Access Compliance Report

Public Rights-of-Way

(Curb Ramps)

Intersection ID: 45246	Main Street: BEGONIA_DR	Cross Street: KODIAK_CT	Location: SW
ADA ID: 197FDAF82F2C	Ramp Type: BlendTrans1	Initial Pass/Fail: Fail	Overall Compliance: No
Severity Score: 12.5			
Codes/Mitigation Info/Possible Solution		Field Measurements/Component Compliance

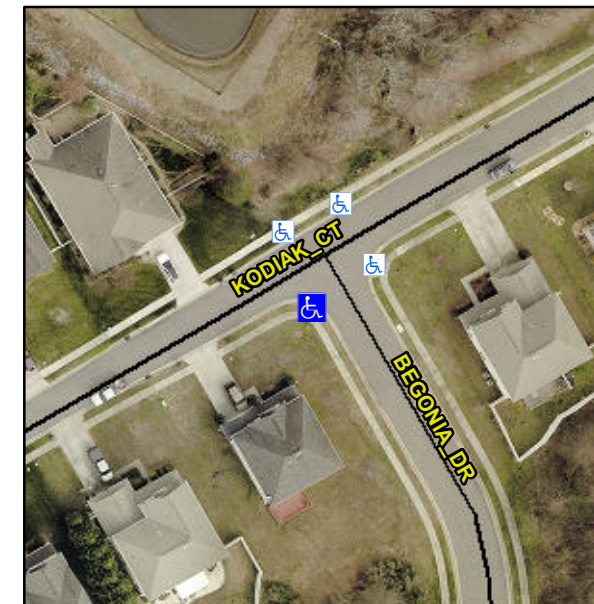
PROW/ADA:

Not Found, R304.5.3

Compliance	Description	Data	Compliance	Description	Data
N/A	Ramp Length (in)	47.0	Yes	BlendTrans Slope (%)	4.3
Yes	Ramp Width (in)	48.0	No	BlendTrans XSlope (%)	6.8
N/A	Flare Type LT	N/A	N/A	Flare Type RT	N/A
N/A	Flare Slope LT (%)	N/A	N/A	Flare Slope RT (%)	N/A
N/A	Flare Traversable LT?	N/A	N/A	Flare Traversable RT?	N/A
N/A	Landing Length (in)	N/A	N/A	DWS Provided?	N/A
N/A	Landing Width (in)	N/A	N/A	DWS Contrast?	N/A
N/A	Landing Slope (%)	N/A	N/A	DWS Length (in)	N/A
N/A	Landing X Slope (%)	N/A	N/A	DWS Full Width?	N/A
N/A	Landing Curb? (Y/N)	N/A	N/A	DWS Offset (in)	N/A
N/A	Shared Landing?	N/A			
N/A	Gutter Ponding?	N/A	N/A	Gutter Slope (%)	N/A
N/A	Gutter Lip Ht (in)	N/A	N/A	Gutter X Slope (%)	N/A
N/A	Painted X Walk1?	No	N/A	Painted X Walk2?	No
	X Walk 1 Direction	To NE		X Walk 2 Direction	To NW
	X Walk 1 Width (in)	N/A		X Walk 2 Width (in)	N/A
	X Walk 1 Slope (%)	0.3		X Walk 2 Slope (%)	5.3
	X Walk 1 X Slope (%)	3.9		X Walk 2 X Slope (%)	3.1

N/A	Ramp inside XWalk1?	N/A	N/A	Ramp inside XWalk2?	N/A
	Road Slope (%)	4.2		Clear Space?	N/A
	Road X Slope (%)	0.7	N/A	Clear Space to XWalk (in)	N/A
N/A	Any Obstructions?	N/A	N/A	Storm Grate/Utility Hazard?	N/A
	Obstruction Type			Storm Grate/Utility Type	
		N/A			N/A
			Yes	Surface Condition? (G/P)	Good
			No	Curb Slope (%)	16.0

Remove & Replace Curb Ramp With Two New Directional Ramps or Equivalent.
